**Sub: Proposal for diversion of 0.4908 Ha of Forest Land for construction of Rural Connectivity Road from Sakyong PWD to Tinek Chisopani Dokey Gaon in East District of Sikkim by Rural Dev. Department, Govt. of Sikkim – Addl. information req.**

**Proposal No. : FP/SK/ROAD/38739/2019**

**Sub: Proposal for diversion of 0.4908 ha of forest land in favour of Rural Mangement and Development Department for construction of rural connectivity road from Sakyong PWD Road to Tinek Chisopani Dokey Gaon in East District of Sikkim -Additional Information -reg.**

SITE PLAN FOR MUCK DISPOSAL

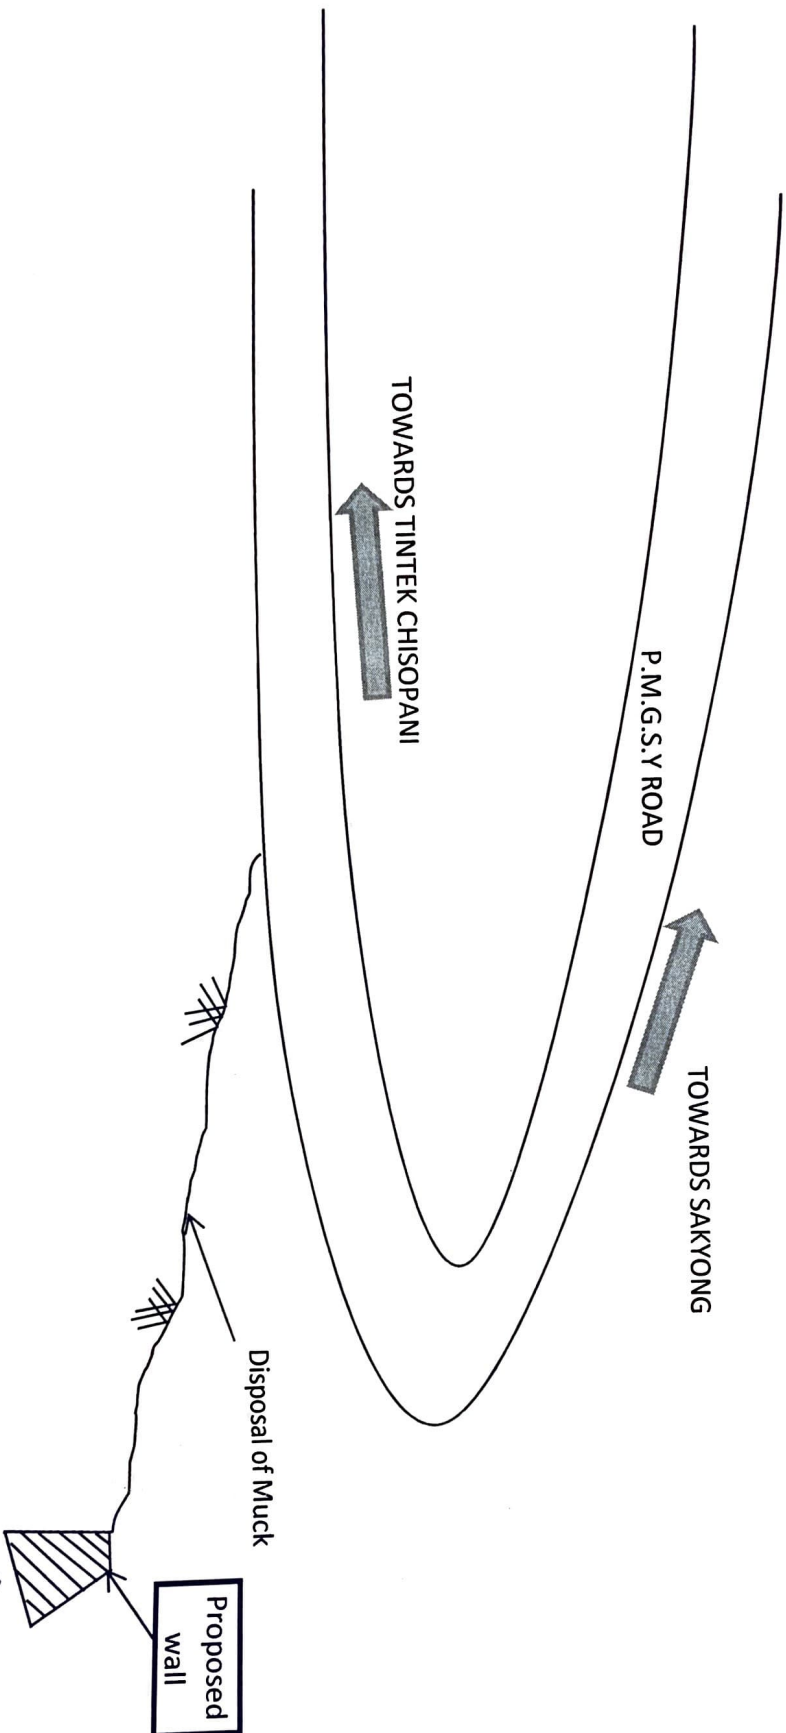
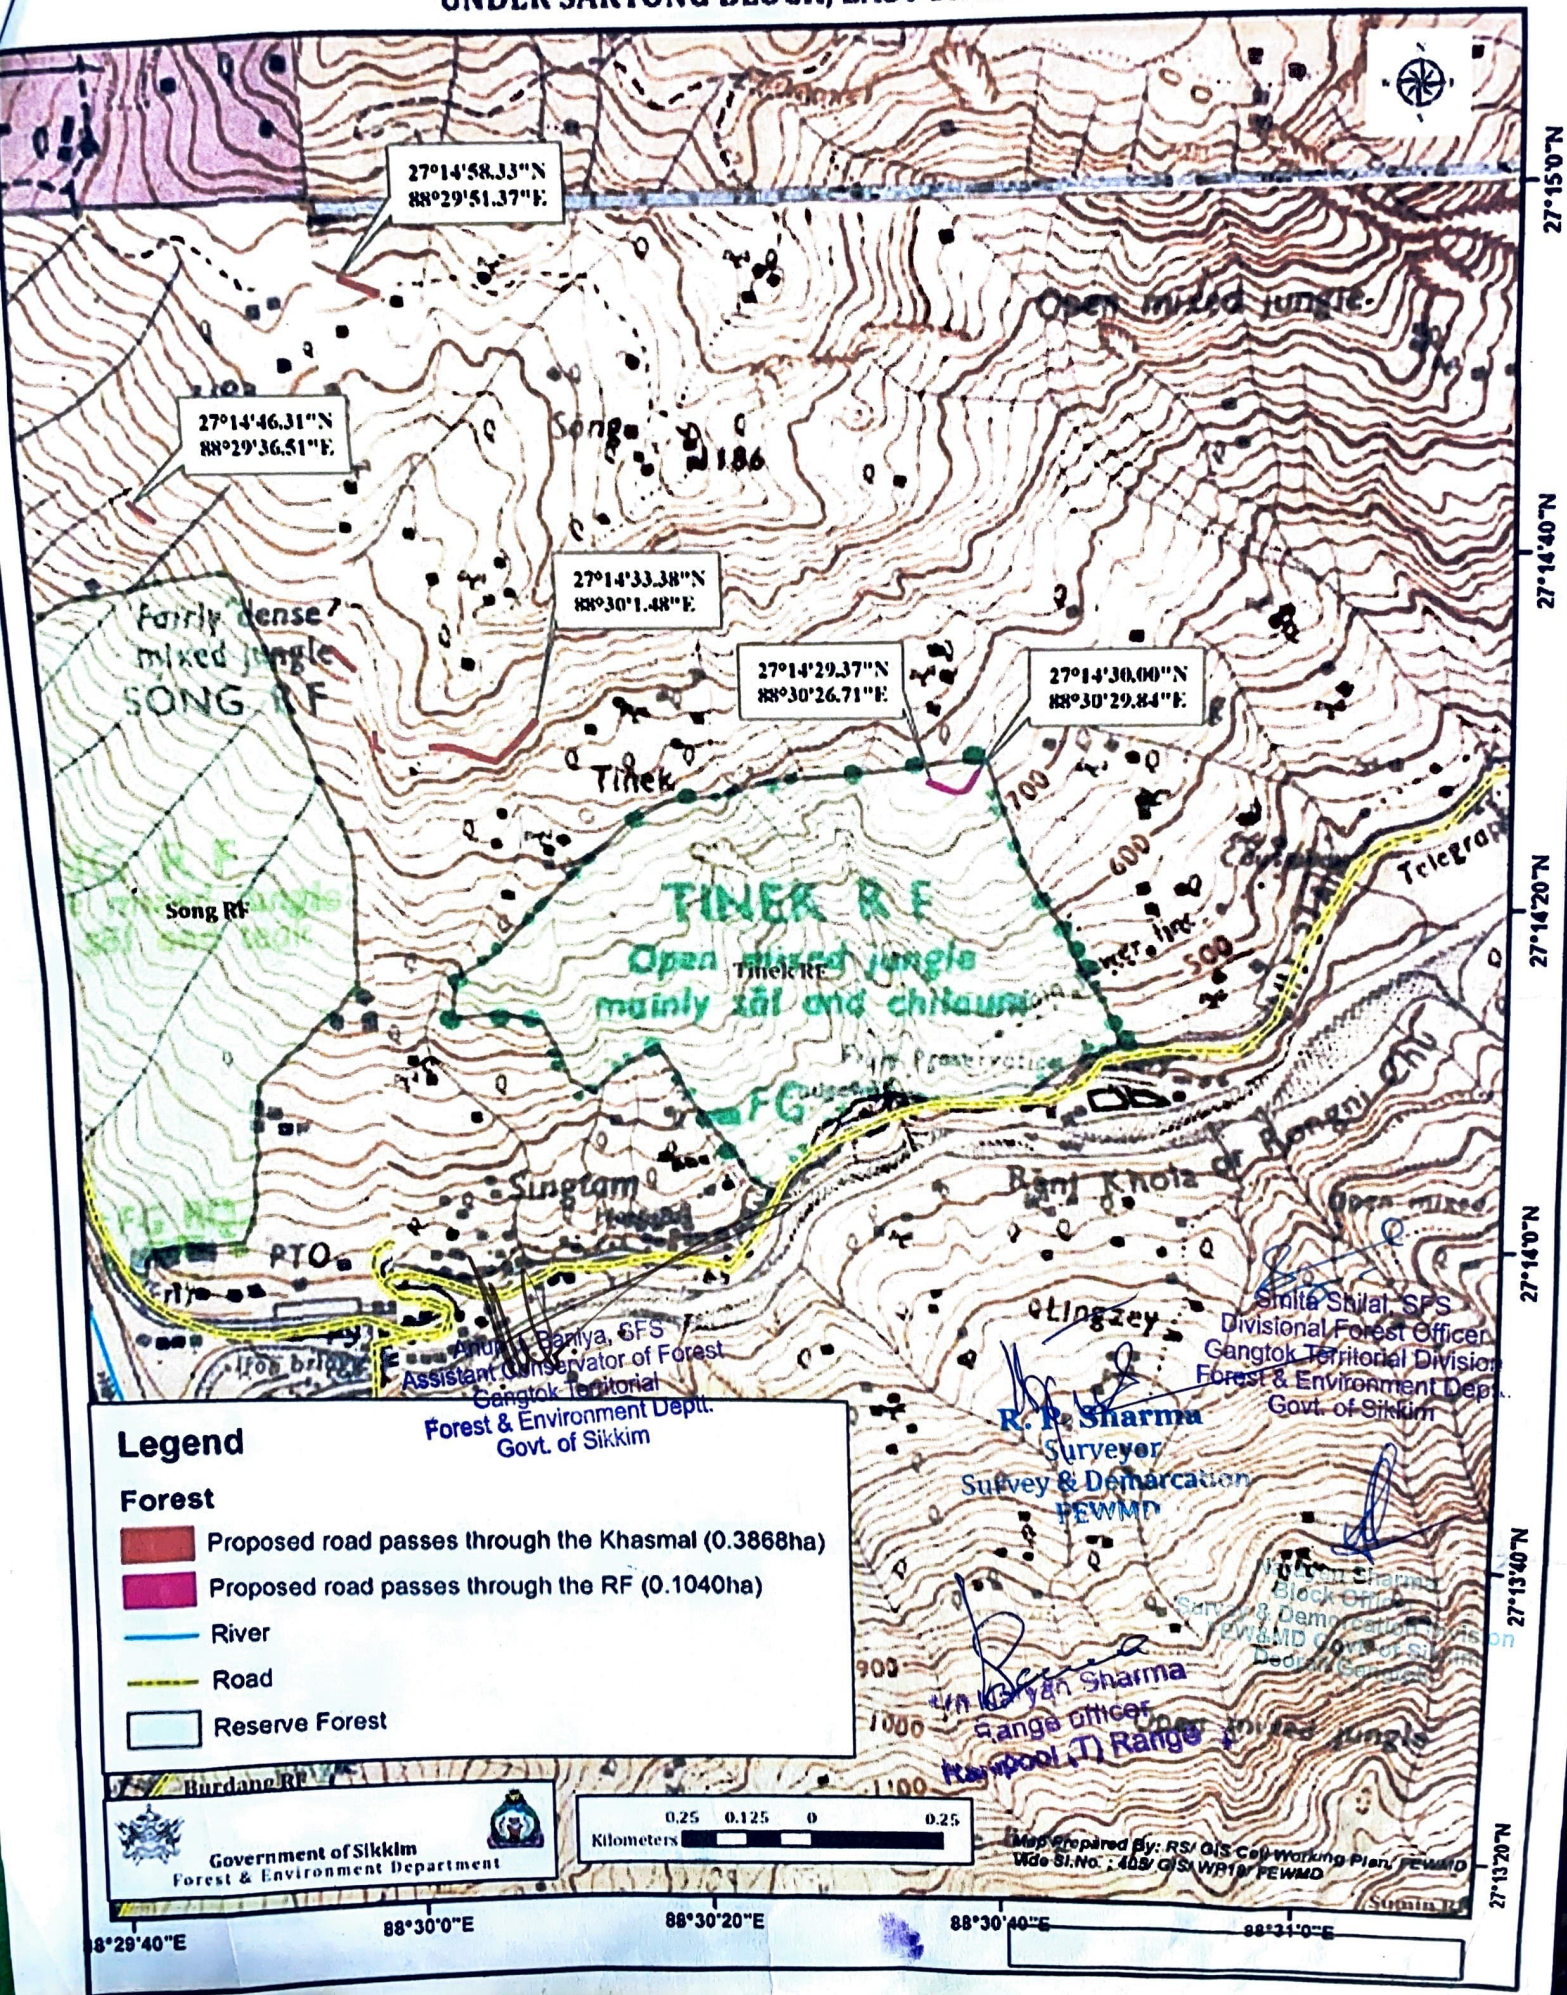
4.	The proposed diversion area is near to river. Therefore, quantity of Muck to be generated with GPS coordinates of muck disposal area/ Muck disposal plan and distance from river area is to be submitted.	As reported by the user agency quantity of muck to be generated along with GPS coordinates of muck disposal area/Muck disposal plan is submitted and uploaded on Parivesh Portal.

## **MUCK DISPOSAL PLAN**

Sl No.	Name of Dumping Site	Location of Dumping Site	Area of Dumping Site (in Ha)	Volume of muck to be dumped (in cum)
1	Tinek	Lat. 27.1430° Long. 88.3002°	0.3960	17668.76
